# SUBMISSIONS REPORT

## PROPOSED BIORESOURCES FACILITY UNIVERSITY DRIVE, CALLAGHAN

Prepared on behalf of:  
THE UNIVERSITY OF NEWCASTLE

SEPTEMBER 2018

Figure 2 –locality plan showing both residential and educational receivers

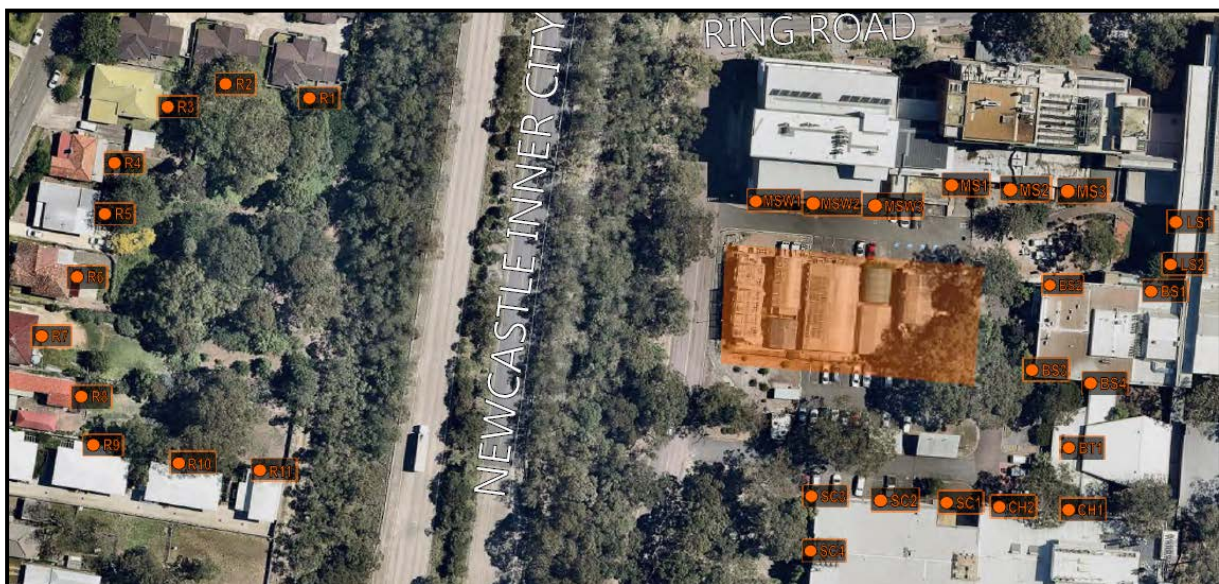
An updated noise and vibration impact assessment has been included in this submission report to include residential noise receivers and modification of construction hours (Appendix 2). The revised report assumes that construction/demolition will be completed during daytime only. The assessment is summarised below.

Receivers surrounding the project site are mixture of educational and residential and are shown in the figure below. Figure 2 provides a locality plan identifying the position of each of the educational and residential receivers in relation to the project site.
